MODEL
2011-2014MY
Optima (QF/TF/TFH)

NUMBER
072

TECHNICAL SERVICE BULLETIN

SUBJECT: MDPS FLEXIBLE COUPLING REPLACEMENT CUSTOMER
SATISFACTION PROGRAM (CS 1604)

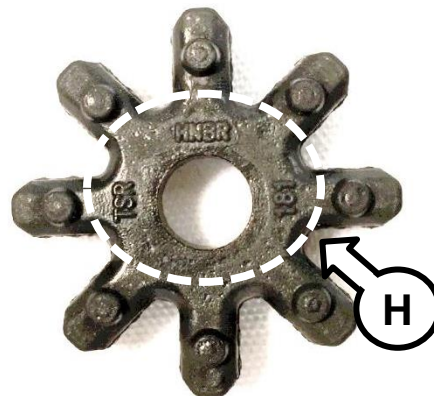
9. Install the new improved flexible coupling.

When assembling, position the flexible coupling so that the embossed markings (H) are facing upward.

The new improved flexible coupling has “HNBR” embossed on the coupling.
